Chattanooga-Hamilton County Regional Planning Agency
RPA Staff Report & Recommendations

Case Number: 2011-068

Special Exceptions Permit: Preliminary Planned Unit Development

Proposed Use: Residential Subdivision- 10 Dwelling Units

2011-0068 Residential PUD

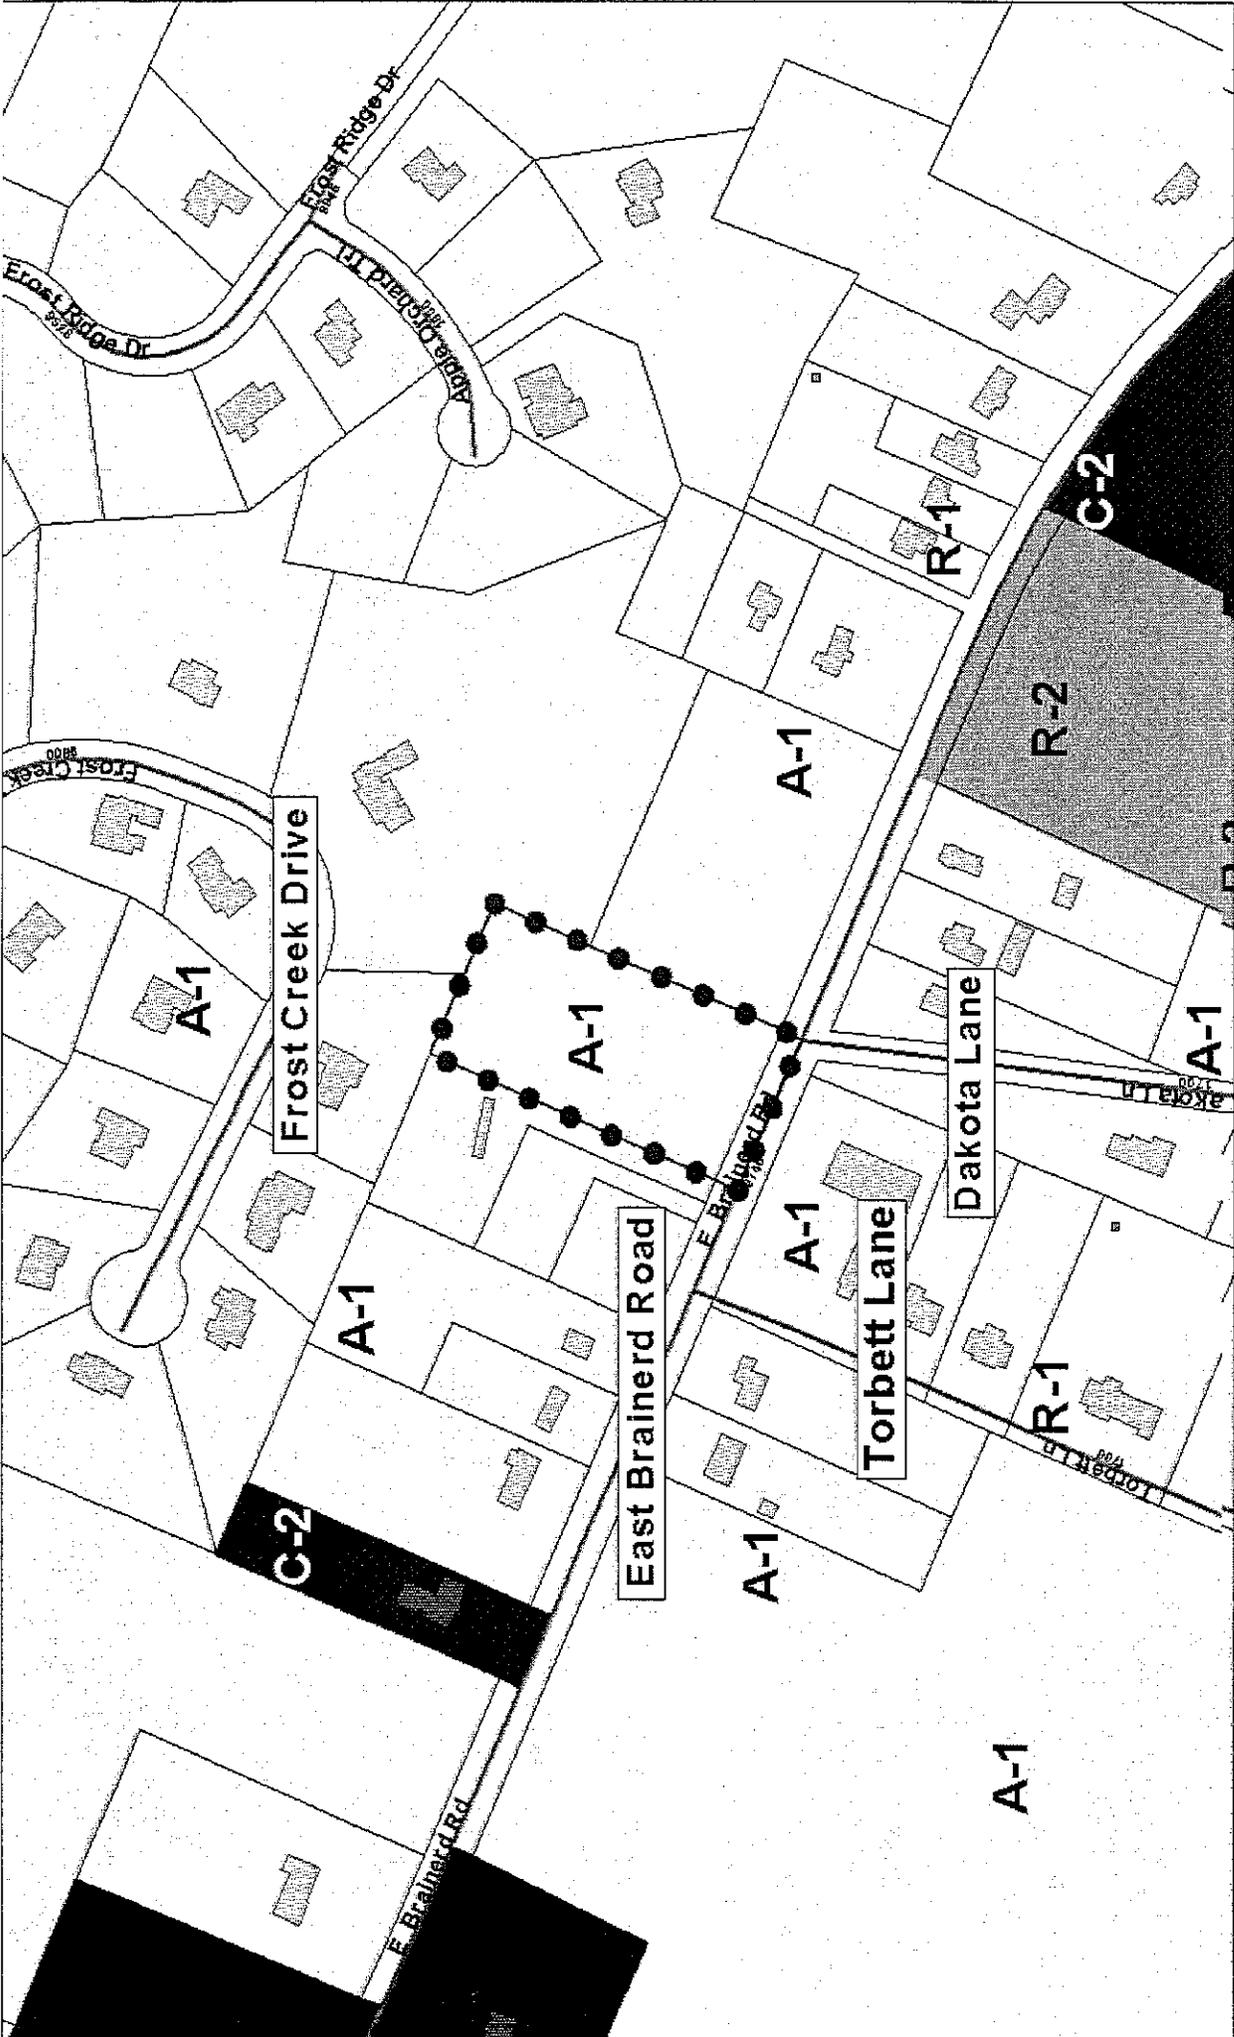
STAFF RECOMMENDATION: APPROVE, subject to screening of Lot 1 with two staggered rows (spaced a maximum of seven feet apart) of shrubs spaced a maximum of eight feet on-center along the frontage of East Brainerd Road and subject to attached Additional Requirements & Conditions.

2. Due to existing drainage in East Brainerd Road a drainage pipe is required in East Brainerd Road at the new road. Show the size, location and number of acres drained for this pipe.

3. Due to the limited capacity of off-site drainage facilities and potential impact on properties down stream, off-site drainage is limited to 80% of the pre-development level. Submit a hydrology report showing pre-and-post development runoff and a drainage plan to limit off-site drainage to 80% of pre-development amounts.

4. Submit detailed drawings of any detention pond or facilities.
5. Add a 15' power, communication, vegetation and fencing clearance easement along East Brainerd Road in lots 1 and 12. Note, that the Government of Hamilton County reserves the right at any time to remove vegetation over 3' high, buildings or fencing in the 15' power, communication, vegetation and fencing clearance easement in lots 1 and 12.

6. In order to have acceptable site distance on East Brainerd Road at the intersection at least 35' from the pavement of East Brainerd Road needs to be kept free of sight obscuring fences, buildings, structures and other obstructions to visibility.

7. The developer discussed the possibility of piping the entire frontage along East Brainerd Road. If this is done there will need to be clean-out structures every 50'.

8. Section 302.5.2 of the Hamilton County Subdivision Regulations requires that intersection center lines must be offset less than 10' or more than 125'. The centerline of the proposed road may be offset between 10' and 125' from the centerline of existing Dakota Lane (Private). This would not meet the regulation. Before any decision can be made on moving the centerline of the proposed road this centerline must be staked.

1. Show a 15' power and communication easement in lots 1 and 12 along East Brainerd Road.
2. Show a 10' power and communication easement along both sides of the new road.
